CITY OF SACRAMENTO

SUBJECT: 1.

5. Tentative Map (P-82-010)

LOCATION: 3301 Sheldon Street

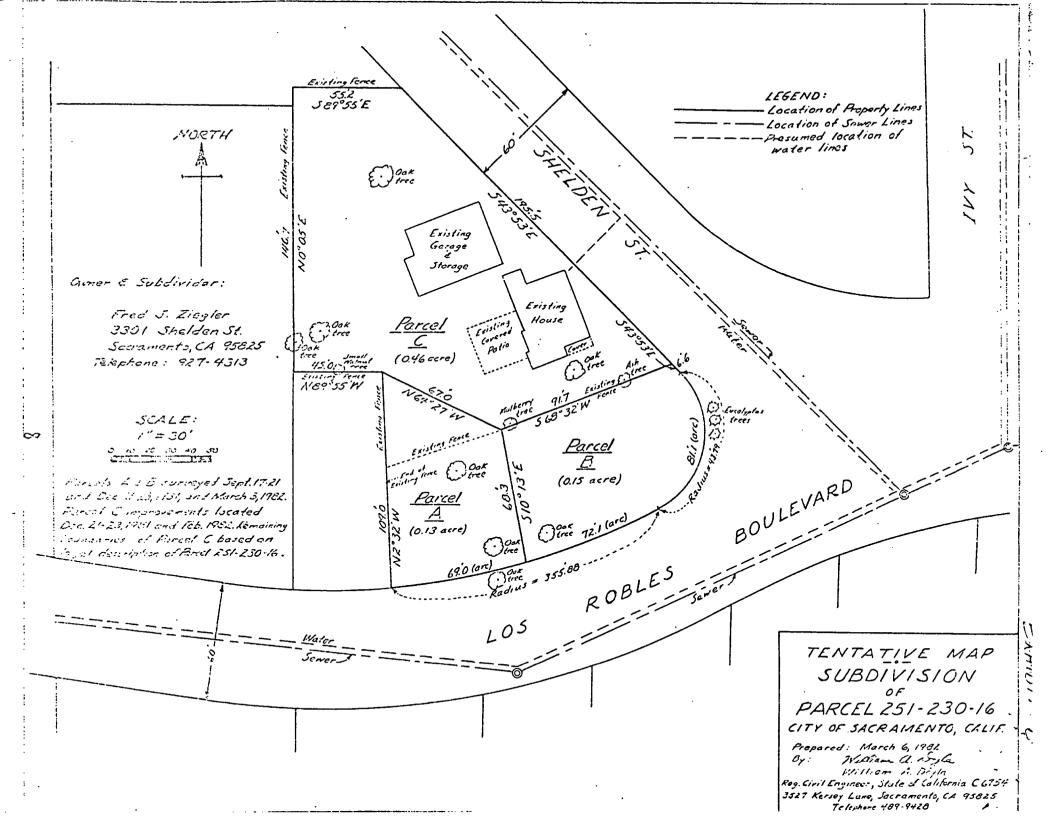
OFFICE OF THE CITY CLERK Staff was in objection to the original map (Exhibit A of CPC report) that was submitted by the applicant because we felt that the minimum lot dimensions as required by the Subdivision Ordinance could be achieved. Therefore, staff suggested a revised lot pattern as shown on Exhibit B of the CPC report. The applicant indicated that this lot design would not be appropriate because of a patio located at the rear of the dwelling on Parcel C. Subsequently, the applicant submitted a revised map (Exhibit D) indicating larger lots. The Commission and staff have no objection to Exhibit D.

- 4. Relocate or abandon the existing gas service line to Lot C, subject to the review and approval of City Engineering.

- A. The Negative Declaration be ratified;
- B. The Tentative Map and Subdivision Modification be approved as shown in Exhibit D, subject to the following conditions:

- 1. Place the following note on the final map: Water and sewer service connections do not exist between the main lines and Parcels A and B.
 - 2. Enter into an agreement with the City to participate in any future assessment districts to provide street improvements and public drainage, water and sewer facilities. A note shall be placed on the final map referencing the agreement.

5. A note shall be placed on the final map that all existing trees on site, including those significant trees on the eastern portion of Parcel B which are not shown on Exhibit A, shall be retained for their aesthetic and shading qualities (location, type and sizes). Any removal of said trees shall be reviewed and approved by the City Arborist and the Planning Director.

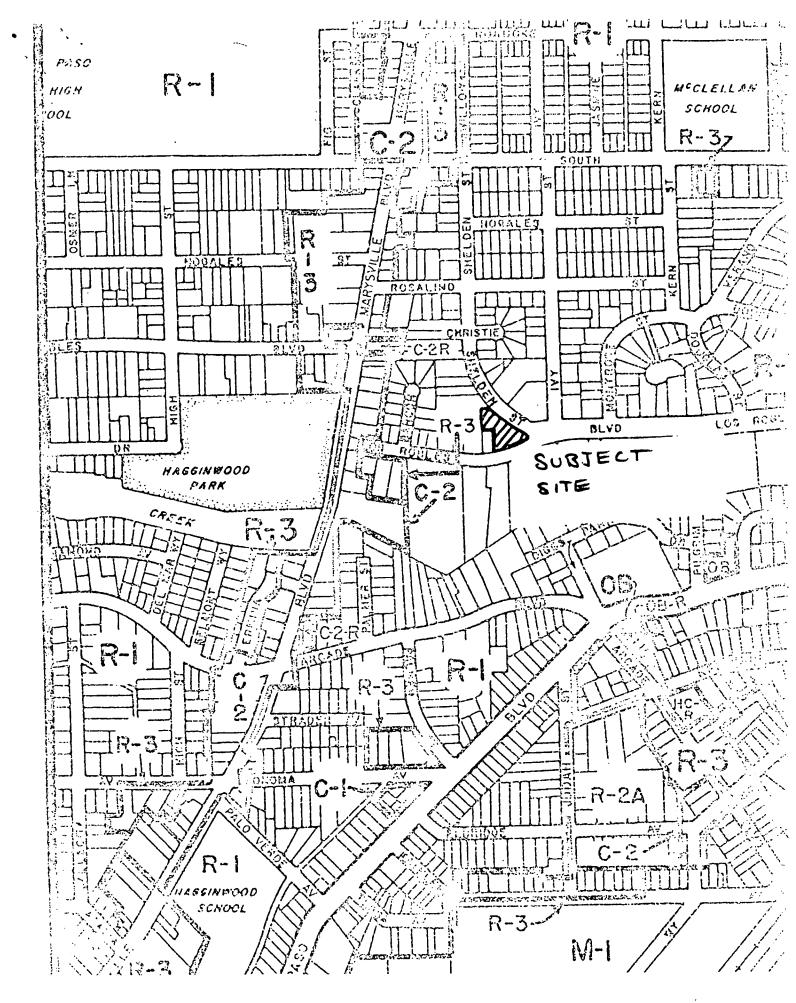
- 1. The subject site consists of a large lot (.75 ac.) currently developed with one single-family residence. Subsequent to Subdivision Review Committee, staff determined redesign of the parcels would meet the minimum lot depth requirement of 100 feet (see staff recommendation Exhibit B). Therefore, staff opposes the applicant's request for variance/subdivision modification to create parcels substandard in length.
- 2. A note should be placed on the final map that all existing trees on site, including those (Eucalyptus?) on the eastern portion of Parcel B which are not shown on Exhibit A, shall be retained for their aesthetic and shading qualities (location, type and sizes). Any removal of said trees should be reviewed and approved by the City Arborist and the Planning Director.

The variance would constitute a special privilege in that the lots of the required minimum of 52 feet wide and 100 feet long can be easily designed on site and still retain minimum setback from the existing residence.

- a. Place the following note on the final map: Water and sewer service connections do not exist between the main lines and Parcels A and B;
- b. Enter into an agreement with the City to participate in any future assessment districts to provide street improvements and public drainage, water and sewer facilities. A note shall be placed on the final map referencing the agreement;

- c. Pursuant to City Code Section 40.1302 (Parkland Dedication), the applicant shall submit to the City an appraisal of the property to be subdivided and pay the required parkland dedication in-lieu fees. The appraisal shall be dated not more than 90 days prior to the filing of the final map;

- Relocate or abandon the existing gas service line to Lot C; subject to the review and approval of City Engineering;
- e. A note shall be placed on the final map that all existing trees on site, including those significant trees on the eastern portion of Parcel B which are not shown on Exhibit A, shall be retained for their aesthetic and shading qualities (location, type and sizes). Any removal of said trees shall be reviewed and approved by the City Arborist and the Planning Director.
